Re: 416 Cambridge Street 40B Development Peer Review

Below please find our response to a comment letter from Weston & Sampson, dated October 30, 2015. For clarity, the comments are in italics while our responses are directly below in normal font.

FIRE TRUCK EXHIBIT
416 CAMBRIDGE STREET
WINCHESTER, MASSACHUSETTS
SCALE: 1"=50'
DATE: 12/02/15

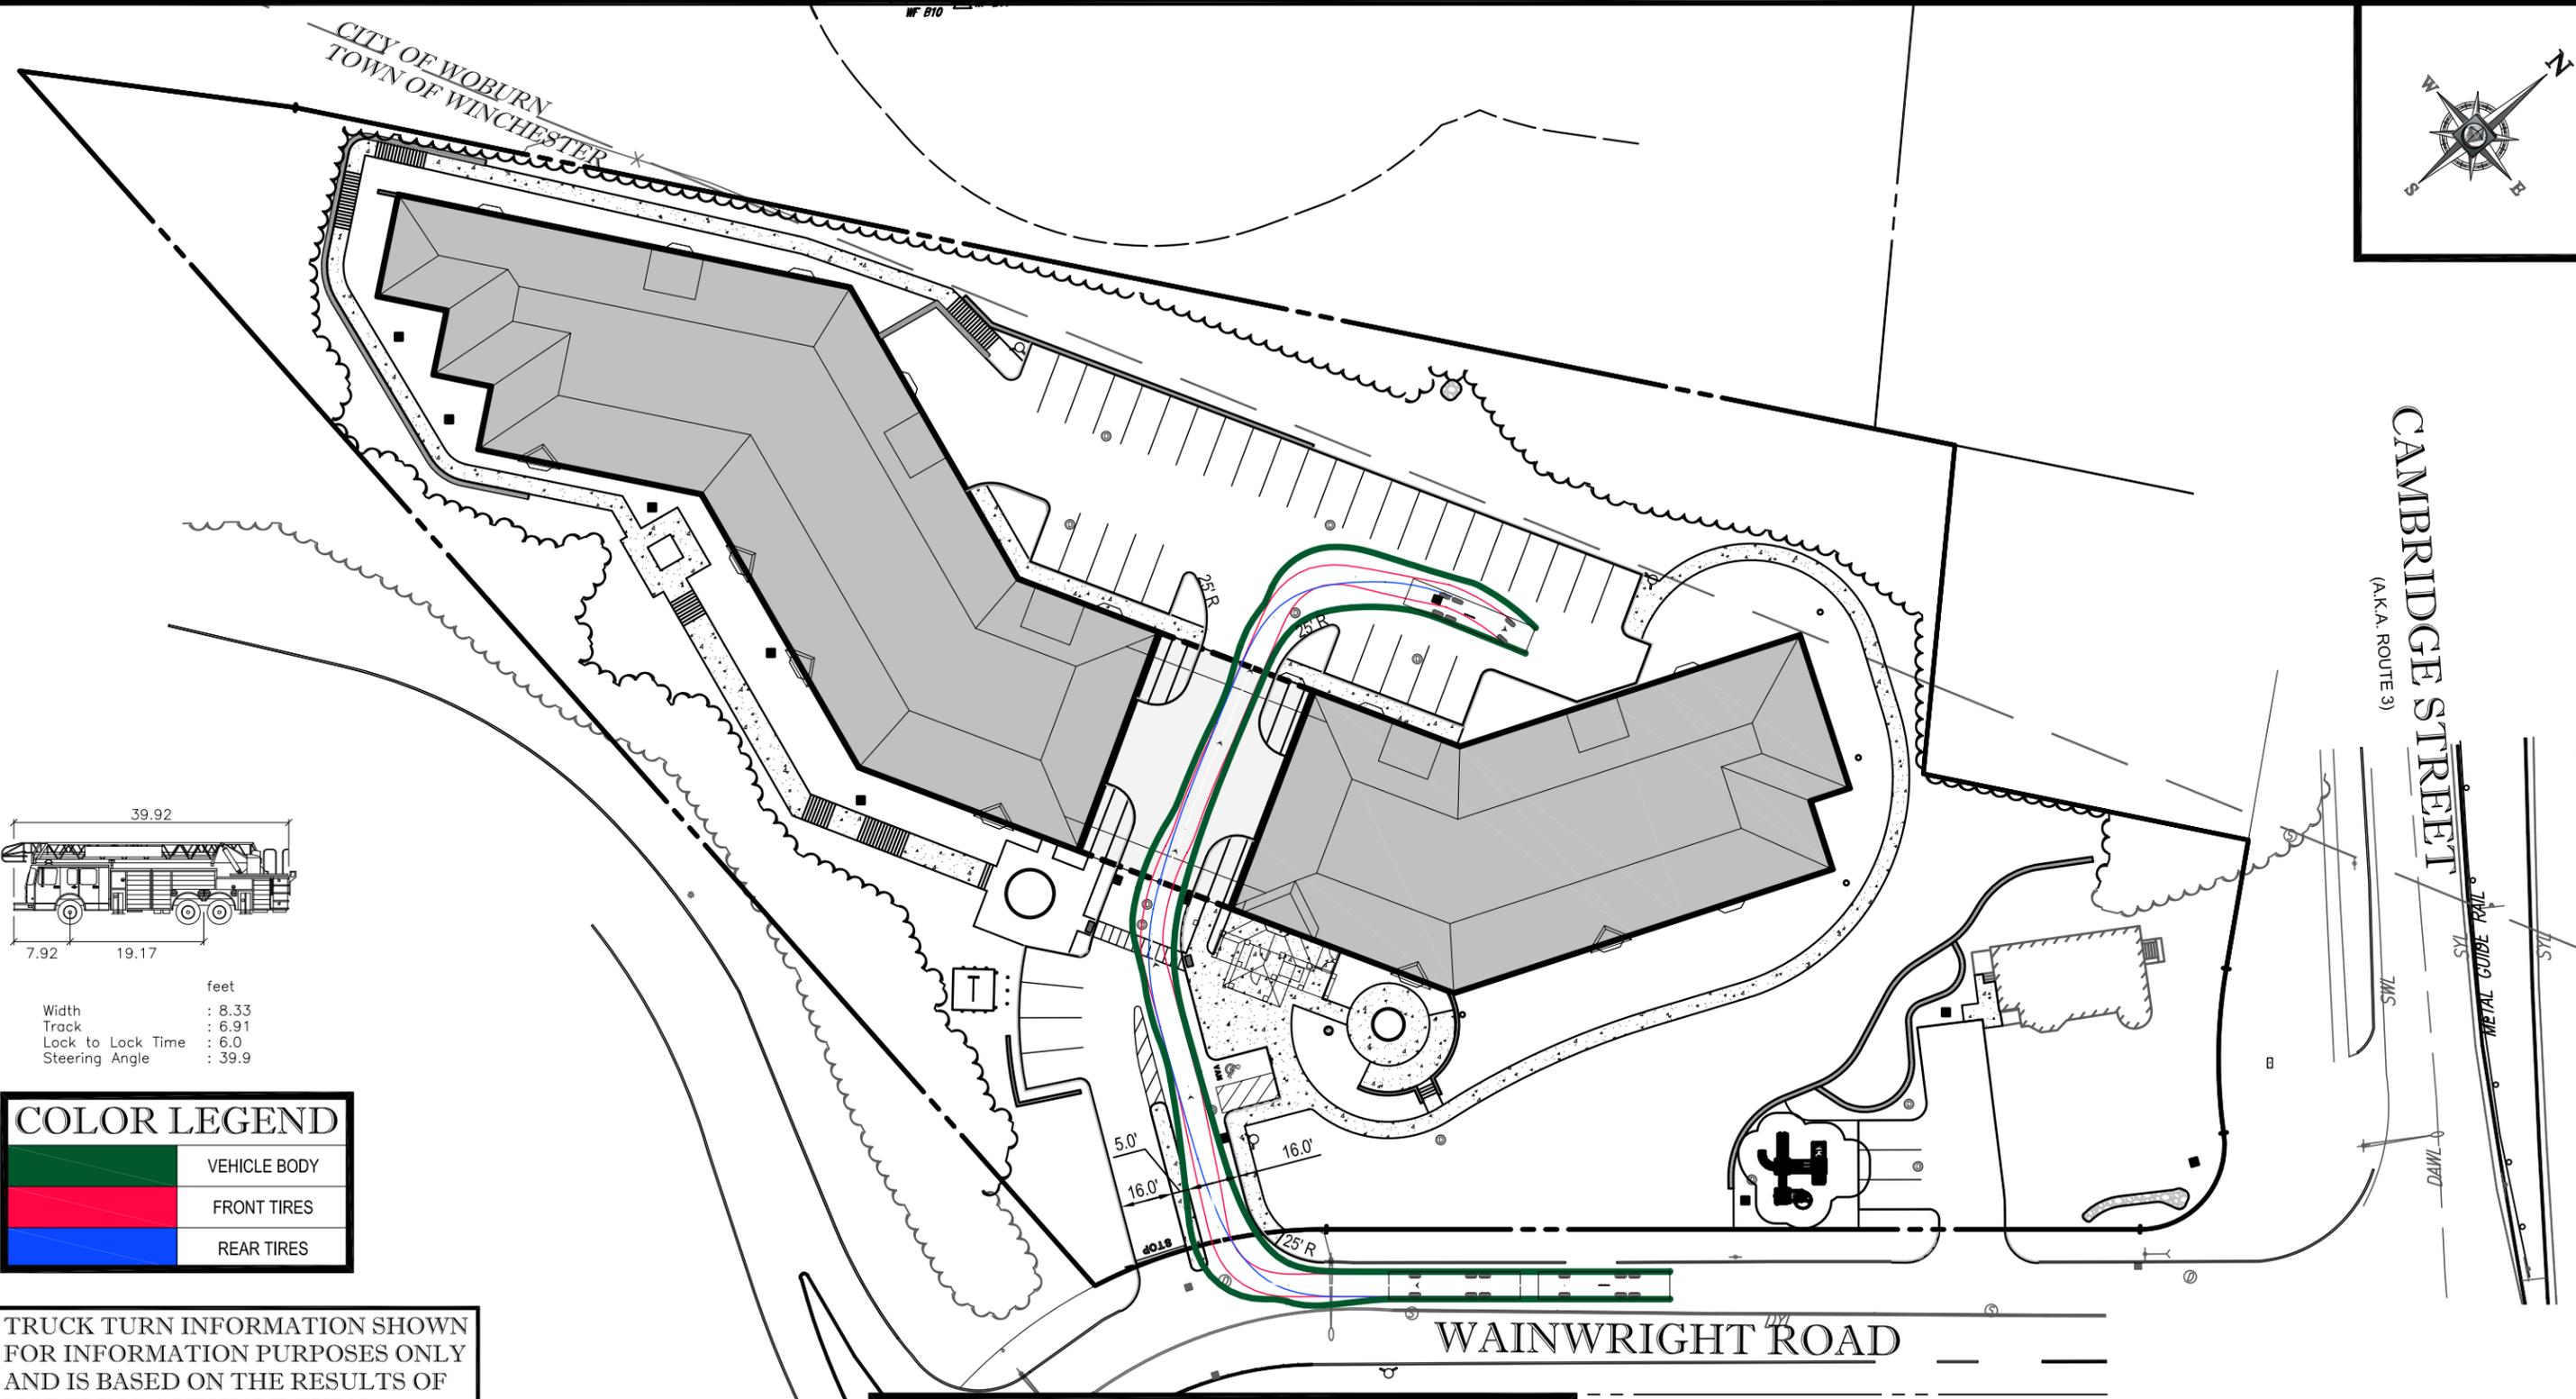
Comment 1: Fire truck access is only provided to a portion of the front and a portion of the back of the building. It should also be noted that the vehicle access to the back of the building must travel under the building, which is a safety concern during a fire situation.

Comment 2: The site plan, including the height of the building "pass-through", has been reviewed with the Winchester Fire Prevention Office and compliance with State Fire Prevention Codes has been confirmed.

Response 2: The size of the truck used in the Exhibit has been confirmed by the Winchester Fire Prevention Officer. Furthermore, the Exhibit (attached) has been modified to show improved access to the rear of the site after curb radii were enlarged in the rear parking lot.
